HISTORIC AND DESIGN REVIEW COMMISSION

HDRC CASE NO: 2019-603
ADDRESS: 219 ADAMS ST
216 WICKES
218 WICKES
LEGAL DESCRIPTION: NCB 942 BLK 1 LOT 5
ZONING: RM-4, RM-4,HS
CITY COUNCIL DIST.: 1
DISTRICT: King William Historic District
LANDMARK: Le Laurin House
APPLICANT: Don Fry/RIVER CITY LOANS INC
OWNER: RIVER CITY LOANS INC
TYPE OF WORK: Demolition of primary structure addressed 216/218 Wickes with construction of a parking lot
APPLICATION RECEIVED: November 01, 2019
60-DAY REVIEW: December 31, 2019; 30 day decision period – January 30, 2019
CASE MANAGER: Stephanie Phillips
REQUEST:

1. Demolish the contributing primary structure addressed 216-218 Wickes.
2. Construct a rear parking pad to include spaces for six vehicles.

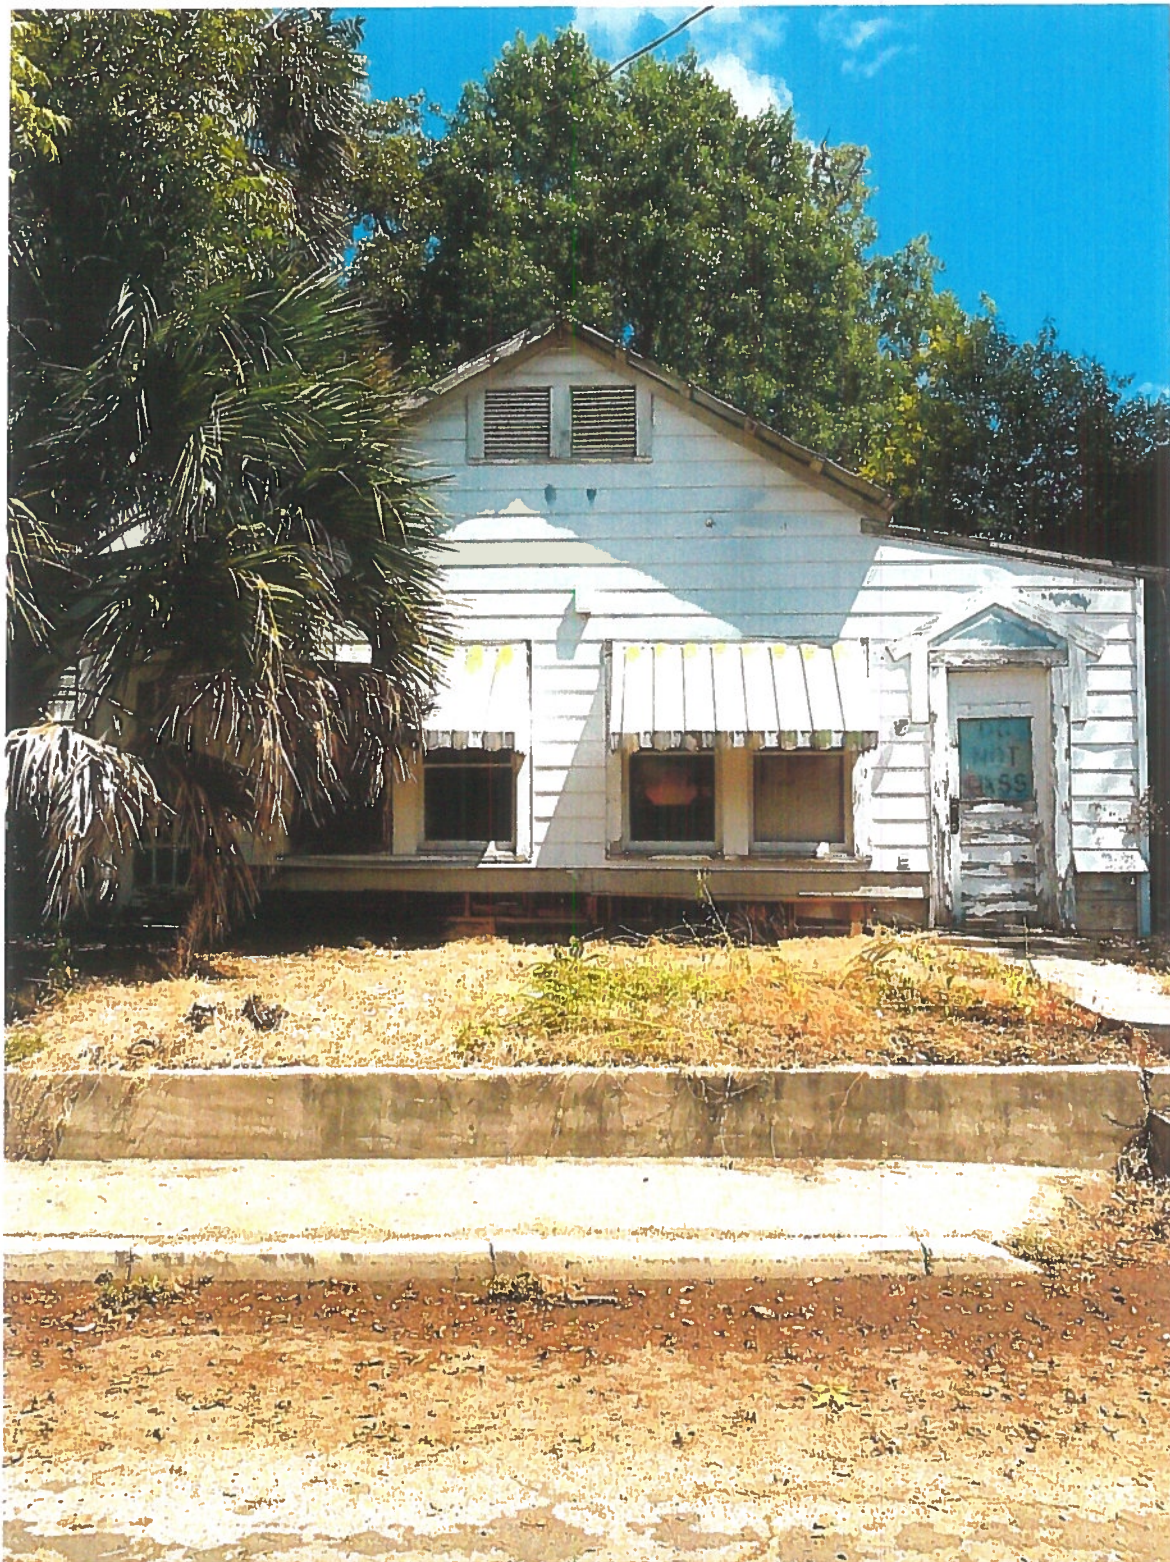
- 2a. PARKING LOT – The applicant has proposed to demolish the existing structure and replace it with a surface parking lot to accommodate six vehicles. The proposal also includes a privacy fence to screen the parking from the public right-of-way along Wickes. The applicant has stated that the parking lot is necessary to meet City requirements for the primary structure on the lot, 219 Adams, which is a 4-unit multifamily structure. This statement has not been substantiated by the applicant in the form of documentation from applicable City departments. Parking variances may also be pursued to waive applicable requirements. Wickes is a primary street that features a historic development pattern of single family or multifamily structures fronting the street, which, overall, is still fairly intact. In effect, the proposal is for front yard parking with a 6 foot tall privacy fence. Staff does not find the proposed surface parking lot appropriate.

2. Staff does not recommend approval of request item #2, the construction of a surface parking lot, based on finding 2a.

Attached is a dimensioned Site Plan (as requested) showing the following:

1. The main house facing Adams Street is to be rehabilitated for four apartments requiring six parking spaces. The six spaces are shown on this plan. The parking is accessed from Wickes Street since the lot is too narrow to locate a driveway from Adams Street. The existing curb cut would be utilized. The drive will be 10 feet wide. The rear yard parking will be buffered from Wickes Street in three ways:

- a. The parking will be set back 20 feet from the property line allowing for the existing sidewalk and a "green" buffer strip to exist.
 - b. Wickes Street is approximately 4 feet below the rear parking surface, further removing the visibility of the parking from Wickes.

- c. The parking will be buffered from the green yard by a four-foot high wooden fence. The top of the fence will be approximately 8 feet above the street level, blocking the view of parked cars.

2. Two large pecan trees in the rear yard will remain.
3. The apartments will have a new deck and green space for the use of the residents between the parking and the historic house.
